Technical Note - 170188-MNP-ZZ-ZZ-RP-C-0001

Project:	KS DC Manchester	Job No:	223169
Subject:	Drainage conditions	Revision:	P01
Prepared by:	Andrew G Dushyanthan	Date:	11 th June 2024

This technical note has been prepared to provide a response with supporting documentation in relation to drainage condition 8 stated in the planning permission letter from Manchester City Council (Planning reference: 137424/FO/2023) for the proposed redevelopment at Simon House, Brownley Road, Manchester, M22 5RA.

Condition 8 - Non statutory Technical Standards

DRAWING TITLE
Drainage General Arrangement

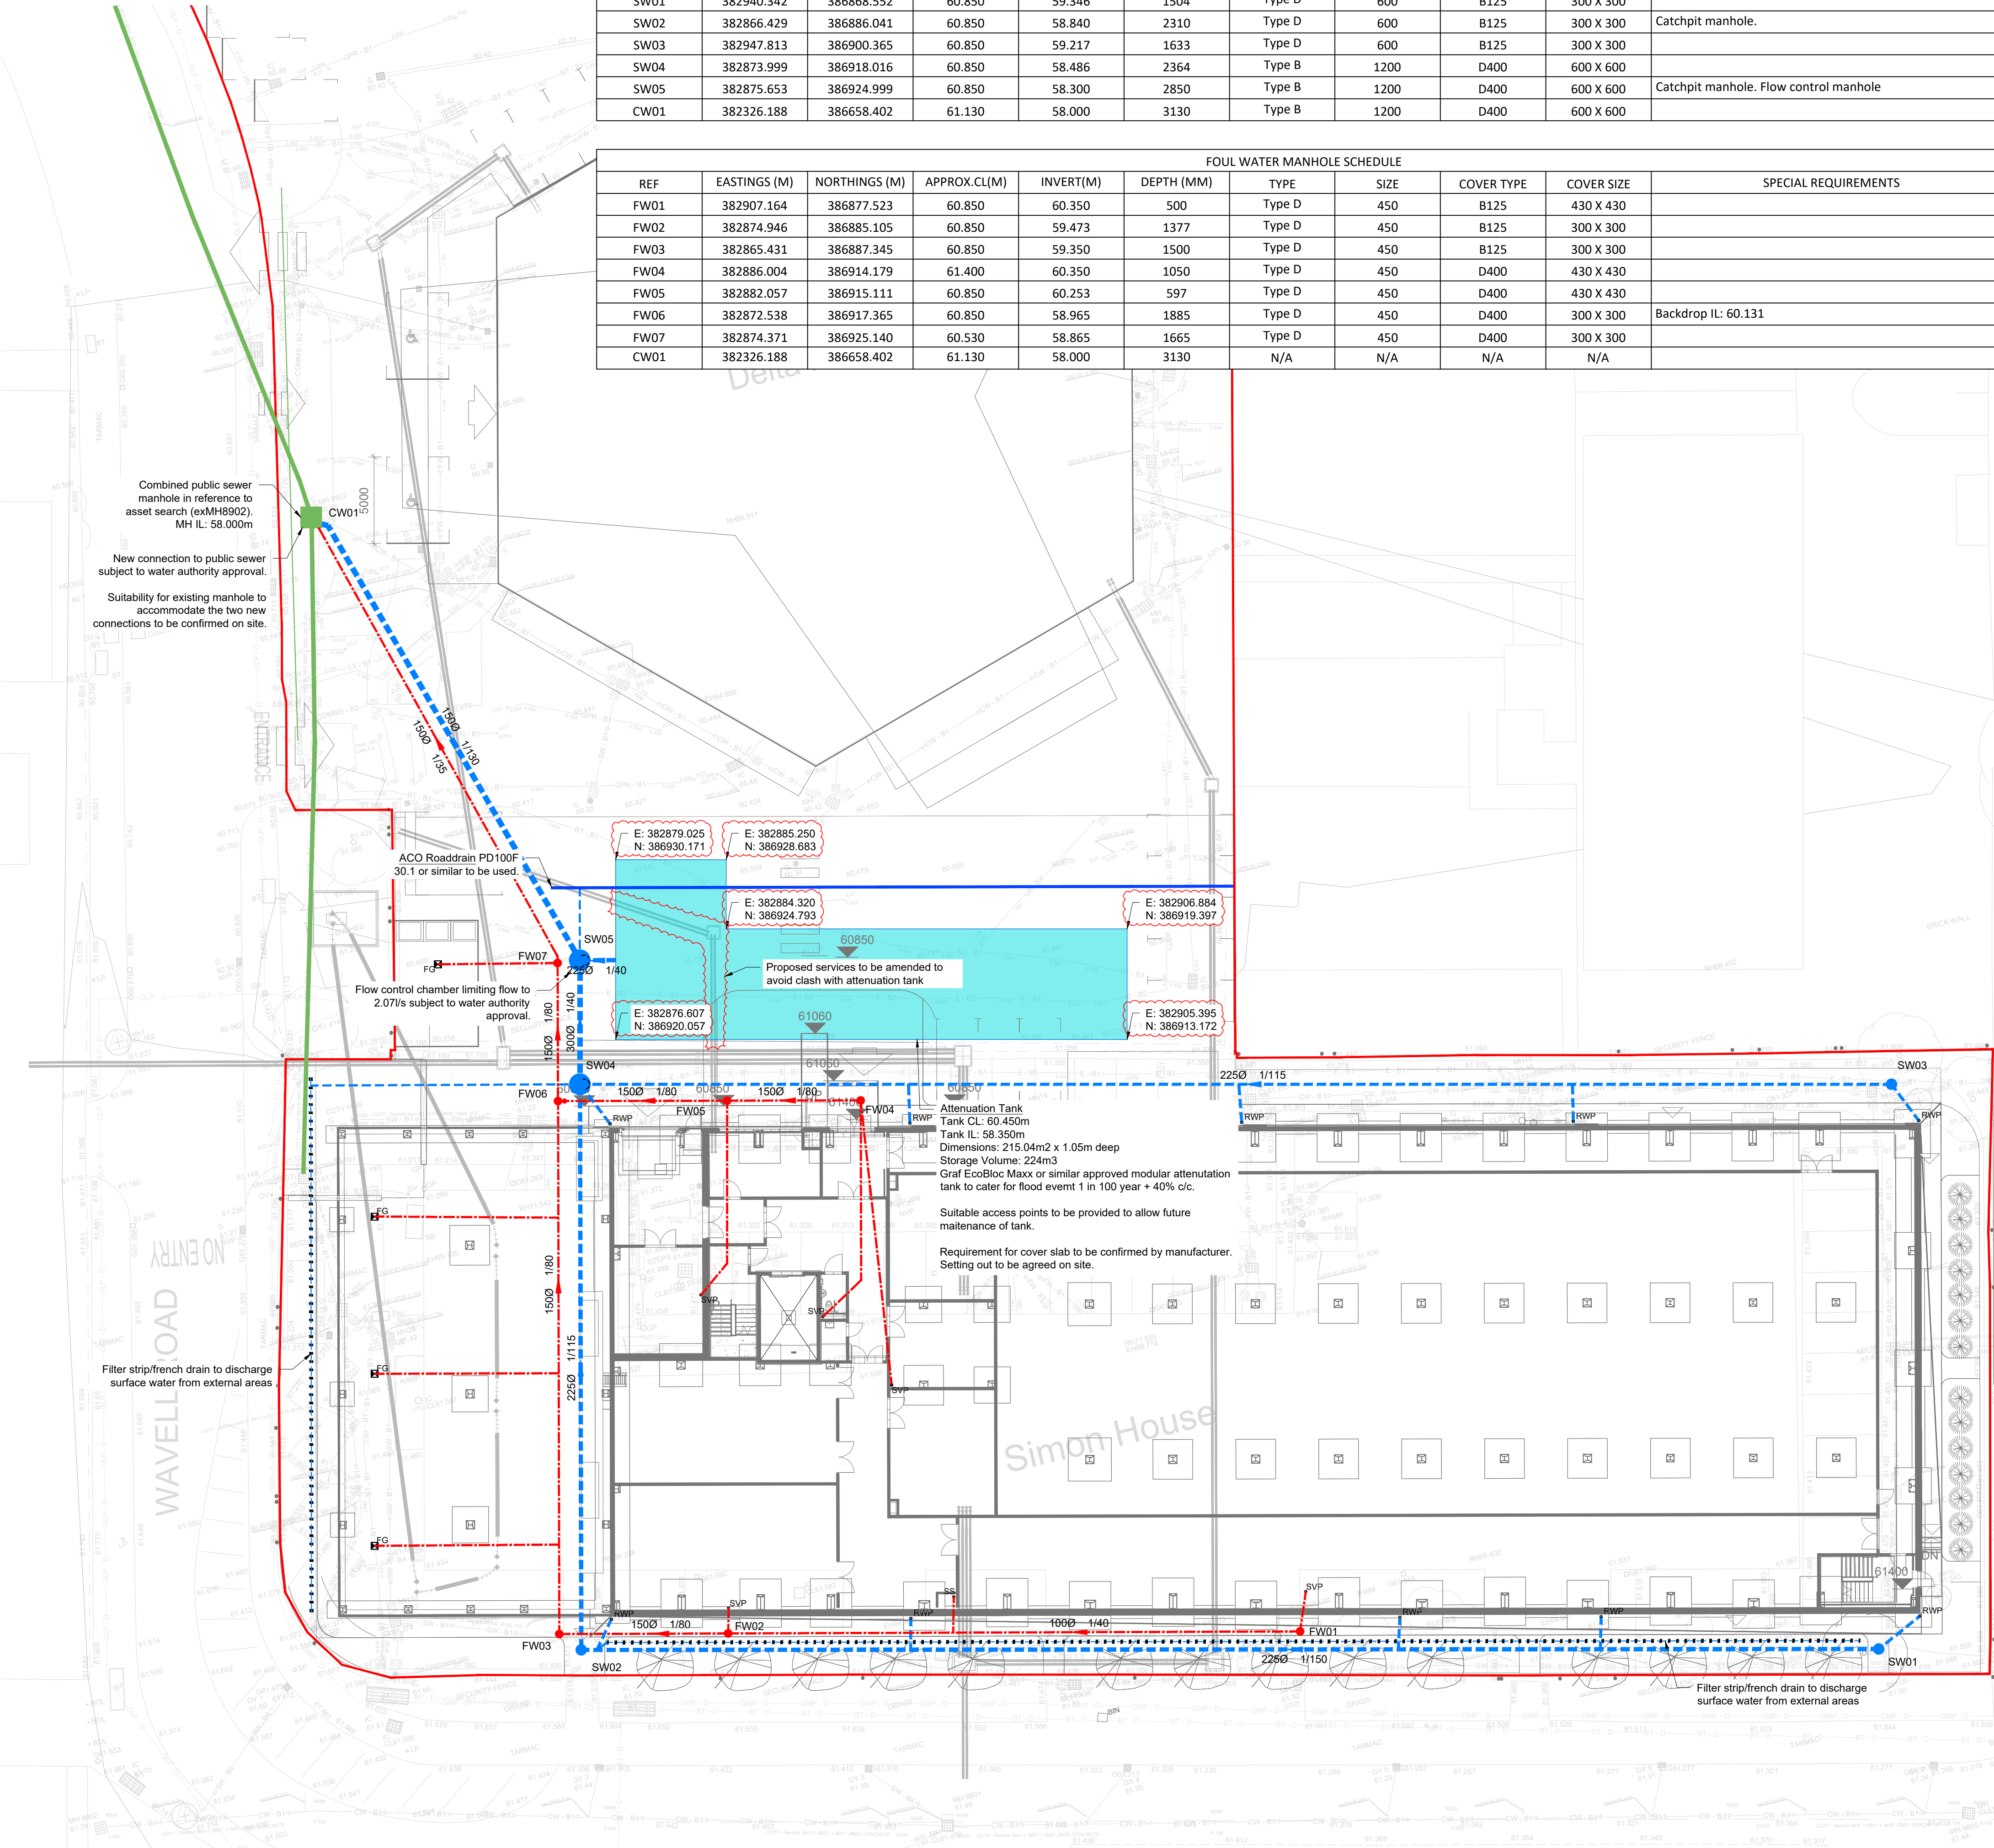
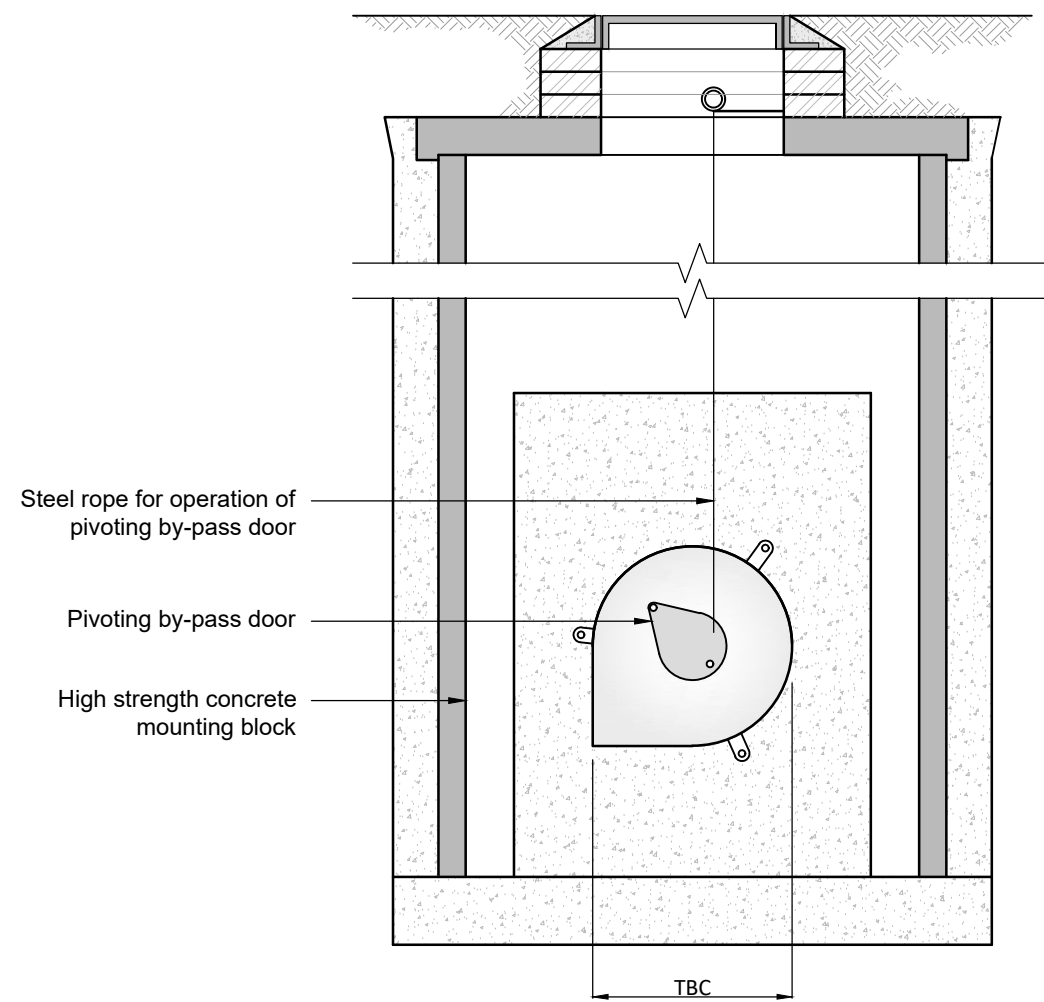
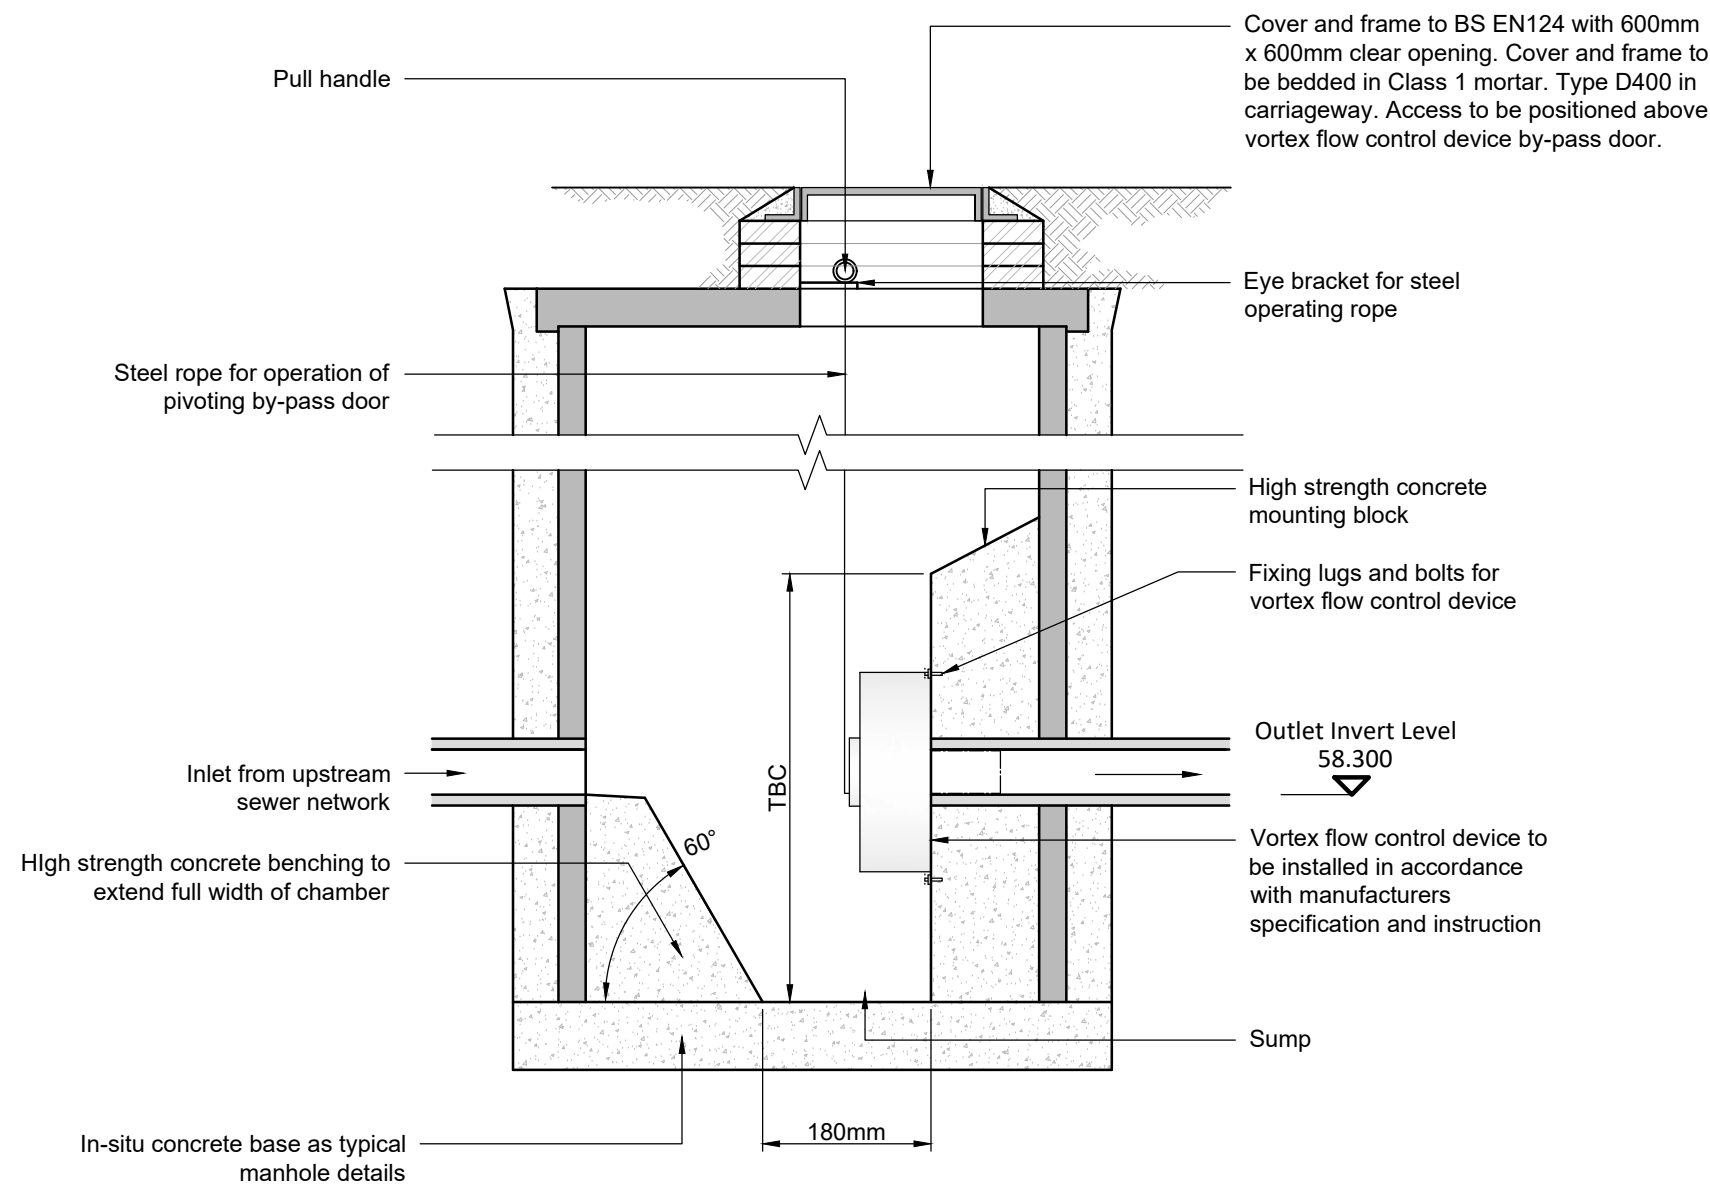
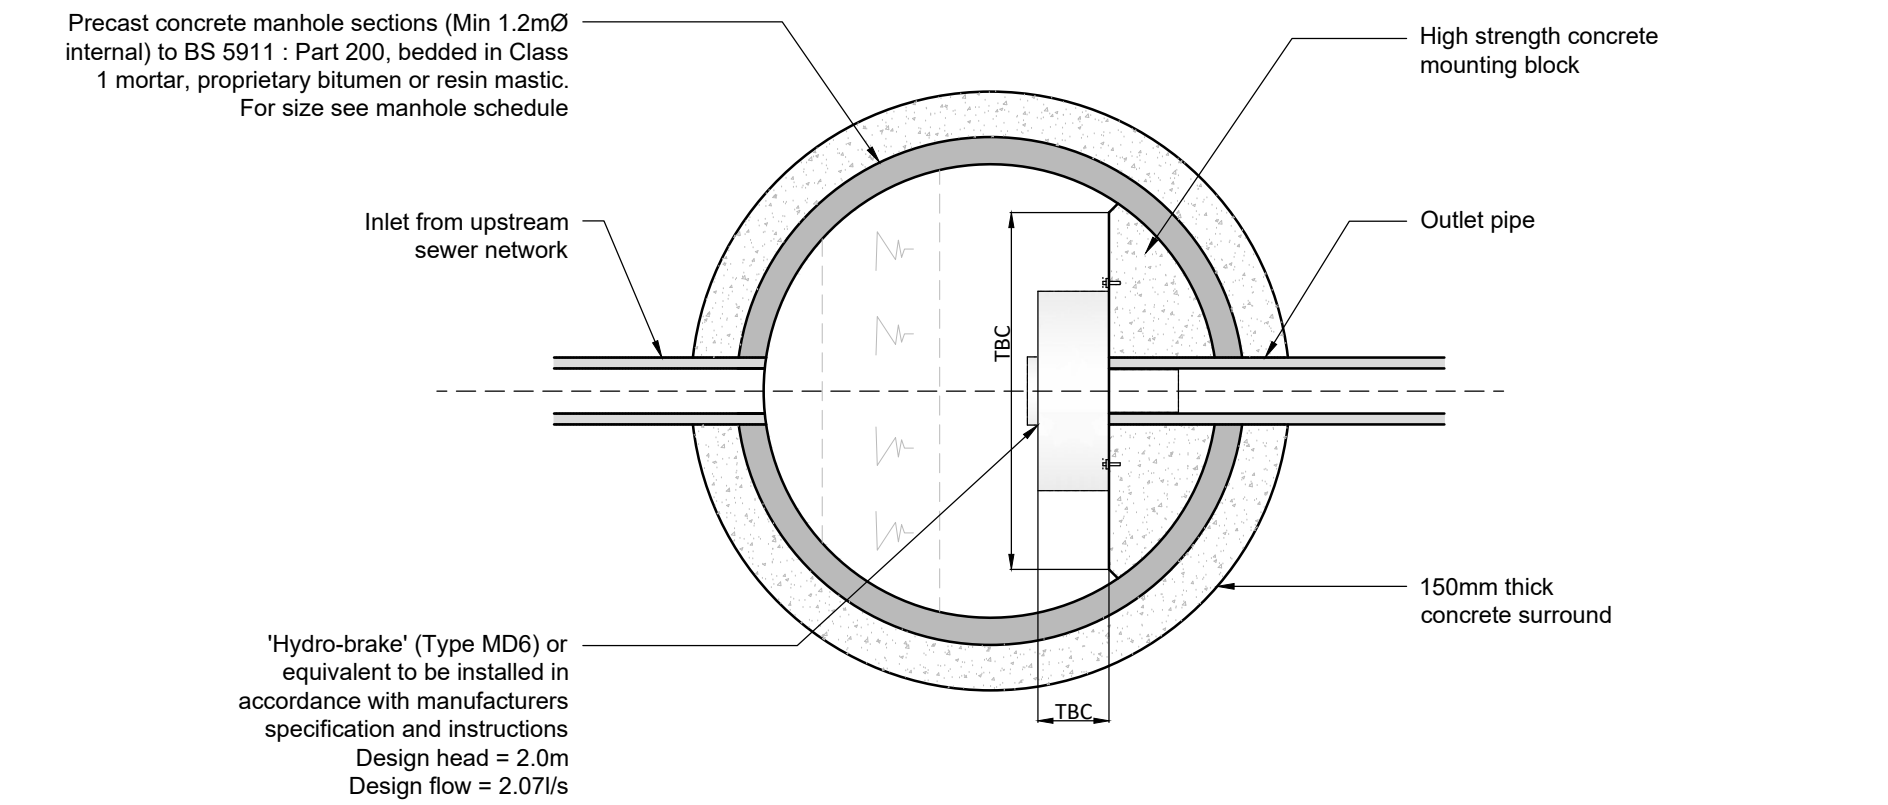
‘A finalized drainage layout showing all components, outfalls, levels and connectivity.’

‘Maximized integration of green SuDS components (utilizing infiltration or attenuation) if practicable.’

- Refer to attached drainage strategy layout showing all proposed manholes, pipes, outfall connection and SuDS features.

- Drainage strategy utilizes use of below ground attenuation tanks and french drains as per the details set out in the approved Flood Risk Assessment and Sustainable Drainage Strategy (SuDS) Report by Lyons O’Neill Structural Engineers. Also refer to attached drainage layout.

Typical Flow Control Manhole
Hydro-brake or Similar approved
(Scale 1:25)

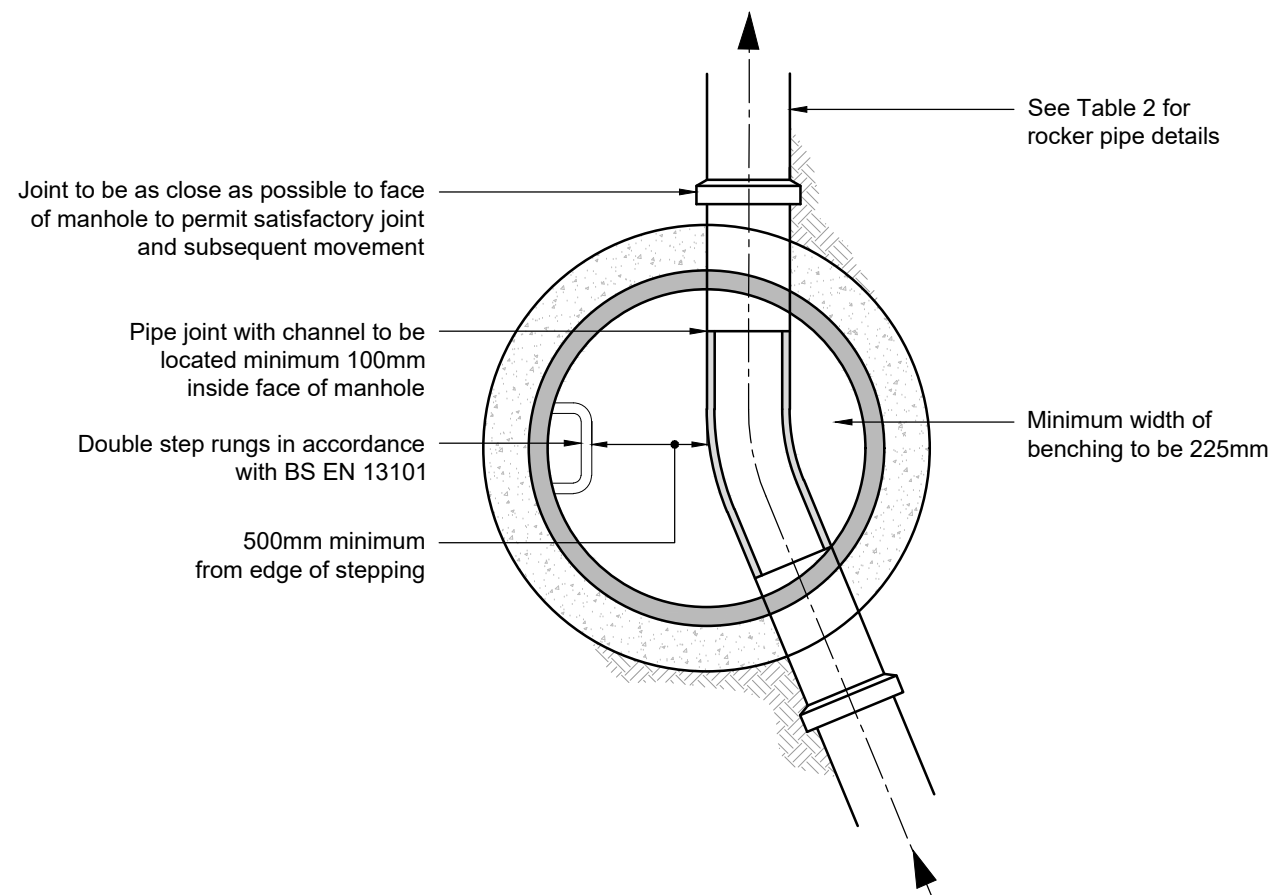
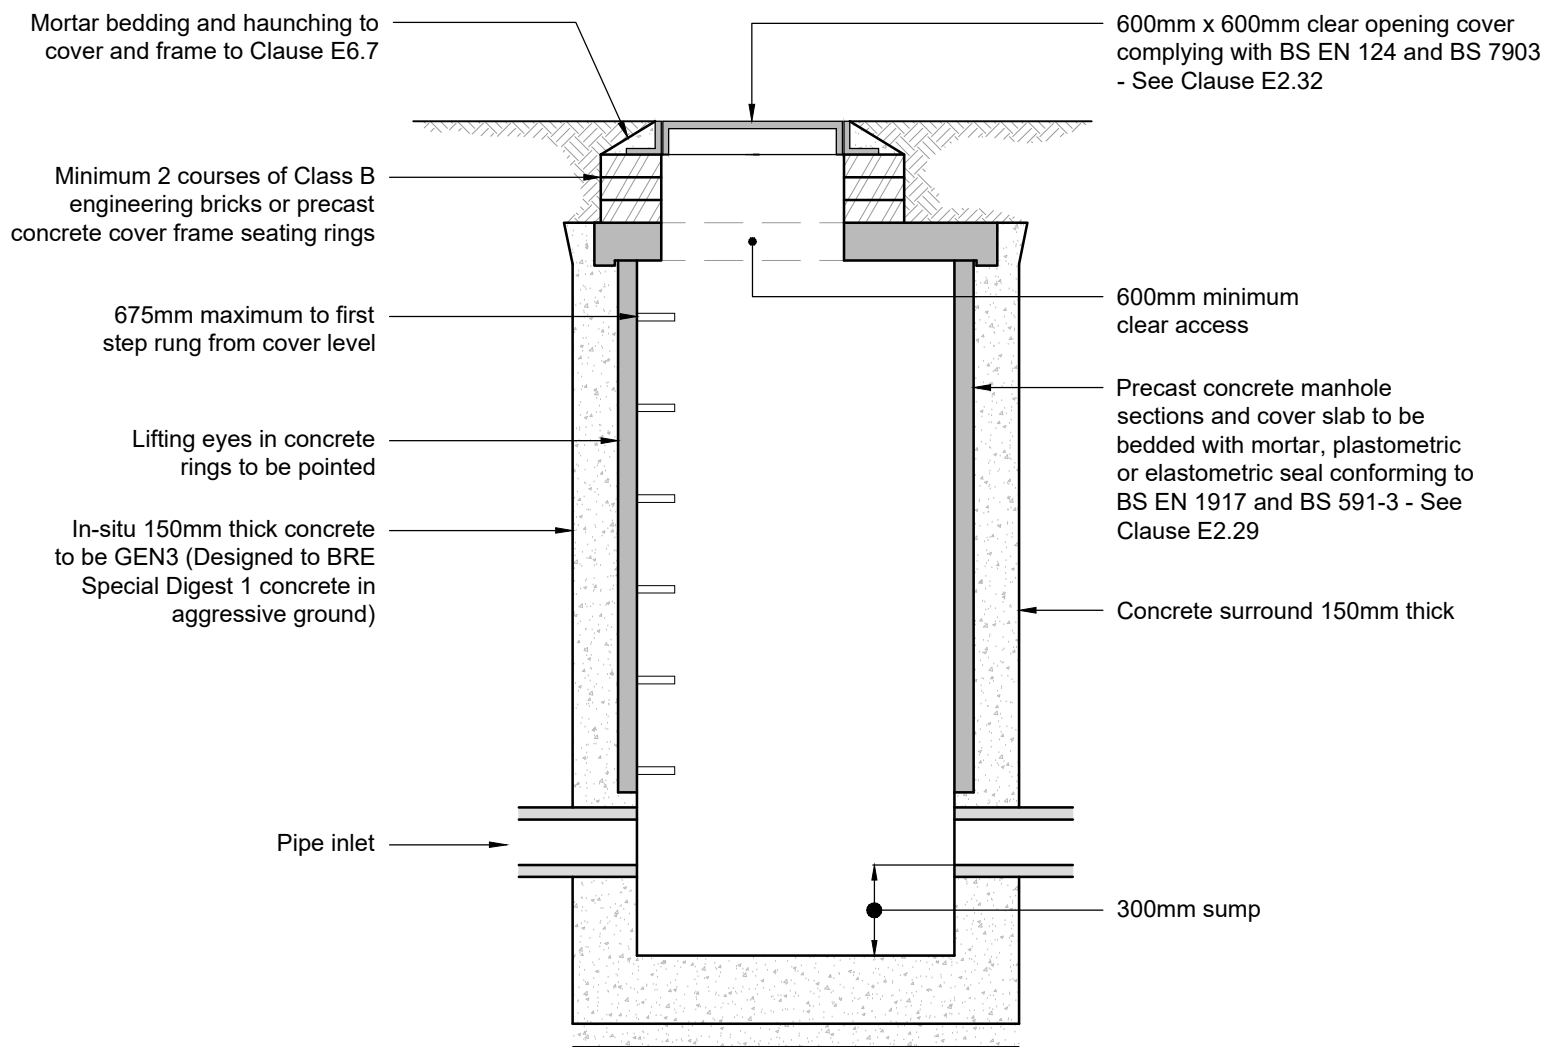
‘Construction details of flow control and SuDS elements.’

- Refer to attached drainage details sheets showing details of all proposed manholes, pipes, and SuDS features.
